RESPONSE TO REQUEST FOR ADDITIONAL INFORMATION

APR1400 Design Certification

Docket No. 52-046

RAI No.: 252-8299
SRP Section: 03.07.02 – Seismic Subsystem Analysis
Application Section: 3.7.2
Date of RAI Issue: 10/19/2015

Figure 1. Accidental Torsion Analysis Model

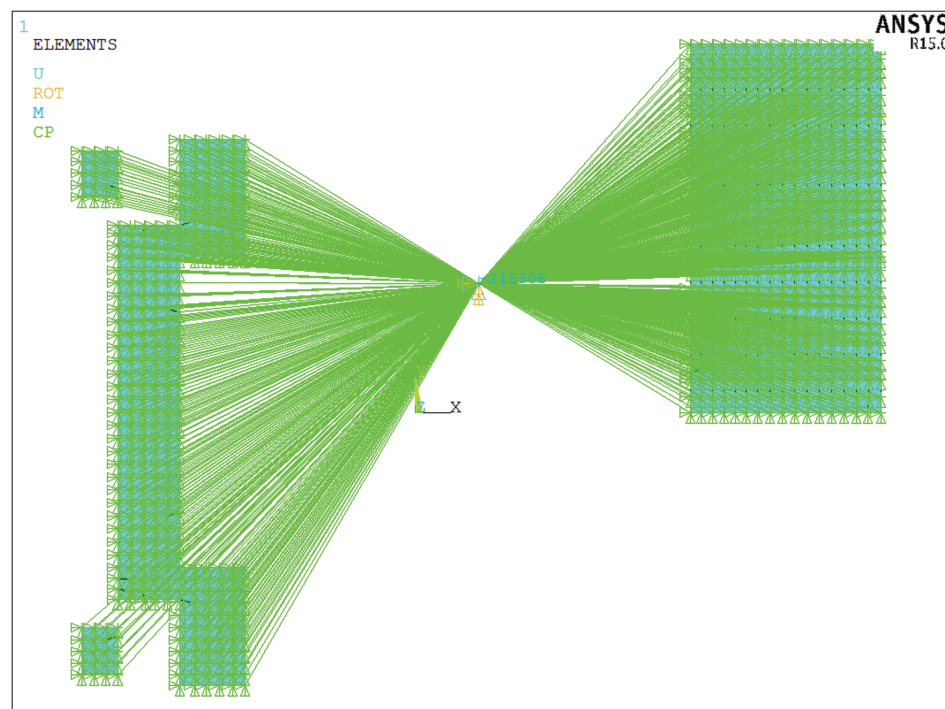
Regarding the consideration of accidental torsion, DCD Section 3.7.2.10 states that additional eccentricity of 5 % of the maximum building dimension, perpendicular to load direction that results in an accidental torque, is applied to the static finite element structural model to calculate element forces due to accidental torsion. To assist the staff in evaluating the adequacy of the consideration of accidental torsion, the staff requests the applicant to clarify how the accidental torsion effects are combined with the computed seismic response, including a numerical example that shows the process.

For developing load combinations with SSE and accidental torsion loading cases, the additional structural ANSYS model is developed, as shown in Figure 1.B. The additional structural model has the same properties as the structural analysis model (Figure 1.A), but all floor nodes are constrained to the mass center, where the accidental torsional moment is applied.

A. Structural Analysis Model at EL. 213.5 ft Floor Level of AB

B. Accidental Torsion Structural Analysis Model at EL. 213.5 ft Floor Level of AB Using Constraint
